Project	IEEE 802.16 Broadband Wireless Access Working Group < <a href="http://ieee802.org/16">http://ieee802.org/16</a> >	
Title	Re-organizing the PN sequences for RS access.	
Date Submitted	2007-01-08	
Source(s)	Fraser Cameron  Dorin Viorel	Voice: +1 403 207 6309 Fax: +1 403 248 1886 fcameron@fmci.fujitsu.com
	Fujitsu Microelectronics Canada Inc. #300, 2710-17th Ave SE, Calgary, AB, T2A 0P6, Canada	Voice: +1 403 207 6311 Fax: +1 403 248 1886 dviorel@fmci.fujitsu.com
Re:	IEEE802.16j-06/027: "Call for Technical Proposals regarding IEEE802.16j"	
Abstract	This document proposes a re-allocation of the preamble related PN sequences, as specified in 802.16e-2005, re-organizing them into 2 equal sub-groups, one allocated for MR-BSs use and the second one assigned for the RSs use. Proceeding in this way the network entry and HO procedures related to the RSs could be optimized in terms of speed.	
Purpose	Text proposal for 802.16j Baseline Document

# Proposed modifications to the PN sequence used by the Base Stations and Relay Stations in a MMR enabled network

Figure 1: 2 tier network topology for 19 cell 3 sector cluster configuration.

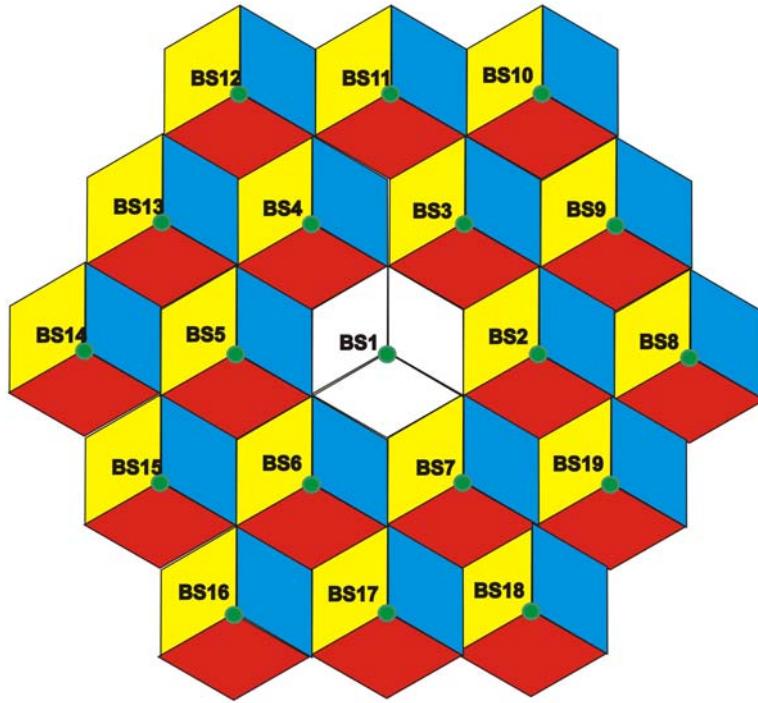
- Triple segment BS allocations (re-using the actual 2G or 3G network structure)
- One segment RS allocations
- 2 tier honeycomb wireless system model (19 cells cluster)
- An average 3 RS per cell (BS), up to a total of 57 per cell cluster. It should be noted that more than 3 RS per cell could be implemented, thus exceeding the proposed threshold of 57 Relay Stations per tier 1 and 2 clusters of cells, under certain limitations (provided that the supplementary related CellID allocations have limited coverage and there no overlapping service area conditions with other Base Station entities reusing the same IDCell).

- 19x3 codes allocating for a 19 cell BS cluster
- 57 PN codes allocated for 57 RS nested within the BS cluster (max 3 RS per cluster)

- Reserve the valid range of ID Cell from 0 to 18, 32 to 50, 64 to 82 for BS. The total number of BS domain codes amounts to a total number of 57 codes.
- Allocate the valid range of ID Cell from 19 to 31, 51 to 63, 83 to 113 for the RS domain. The total number of RS domain codes amounts to a total number of 57 codes.
